**UNITED STATES  
NUCLEAR REGULATORY COMMISSION  
ADVISORY COMMITTEE ON REACTOR SAFEGUARDS  
WASHINGTON, DC 20555 - 0001**

**SUBJECT:** Assessment of the Continued Adequacy of Revision 2 of Regulatory Guide 1.99

During the 668<sup>th</sup> meeting of the Advisory Committee on Reactor Safeguards, November 6-8, 2019, we completed our review of the staff's technical letter report, TLR-RES/DE/CIB-2019-2, "Assessment of the Continued Adequacy of Revision 2 of Regulatory Guide (RG) 1.99." Our Metallurgy & Reactor Fuels Subcommittee reviewed this technical letter report on August 22, 2019. During these meetings, we had the benefit of discussions with the staff and the Electric Power Research Institute (EPRI). We also had the benefit of the referenced documents.

Figure 1. Estimates of the residual (RG 1.99, Revision 2 predicted minus measured values) of  $\Delta RT_{NDT}$  using the current US and international database for (a) welds and (b) base metal.

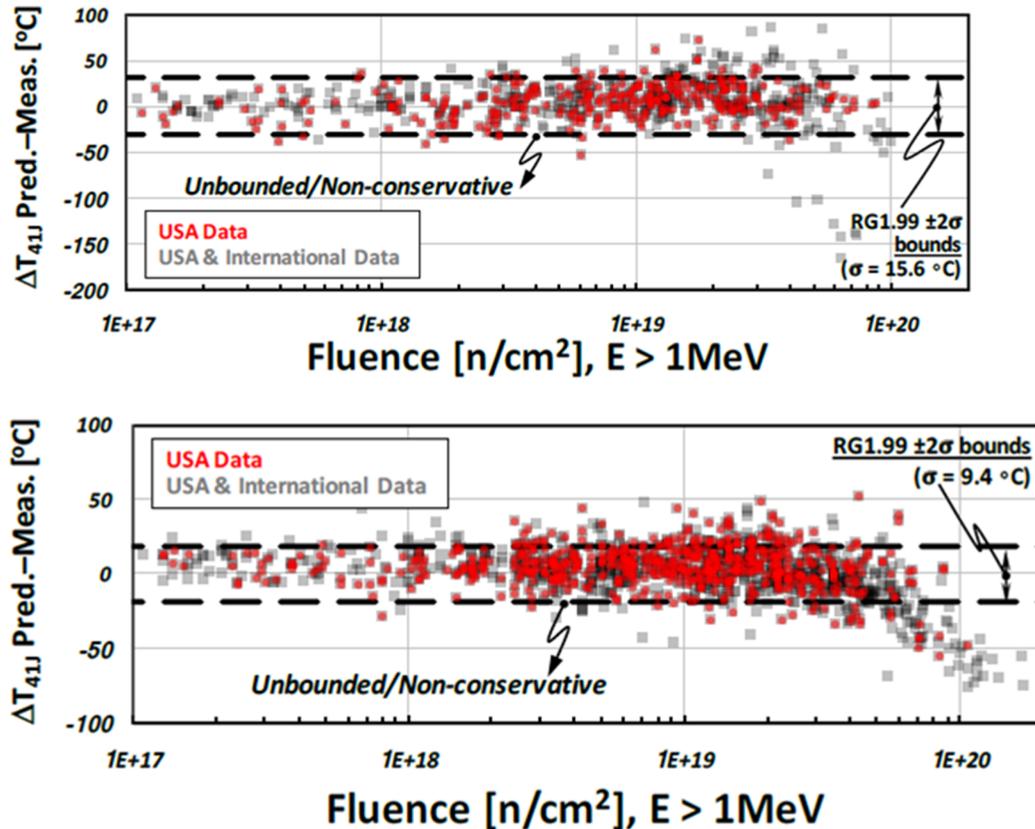
These deficiencies raise potential safety margin issues because resulting estimates of reference nil-ductility transition temperature shift ( $\Delta RT_{NDT}$ ) may be non-conservative for plants with vessels exposed to higher levels of neutron fluence anticipated during subsequent license renewal. Figure 1 contains plots of the residual of  $\Delta RT_{NDT}$  for both welds and base metal. Residuals are computed as the difference between the RG 1.99, Revision 2 predicted value and the measured value from the current large embrittlement data base, incorporating both US and international data. A negative residual value indicates non-conservatism. The technical letter report analysis suggests that between fluences of  $3 \times 10^{19}$  n/cm<sup>2</sup> and  $6 \times 10^{19}$  n/cm<sup>2</sup> ( $E > 1$  MeV), the mean residual becomes increasingly non-conservative.

Standard deviation values from the RG are used as a defined margin in RPV embrittlement calculations (horizontal dash lines in Figure 1). The current large embrittlement database has a larger standard deviation (greater scatter) than the original database used to develop the ETC in the RG. This represents another potential non-conservatism.
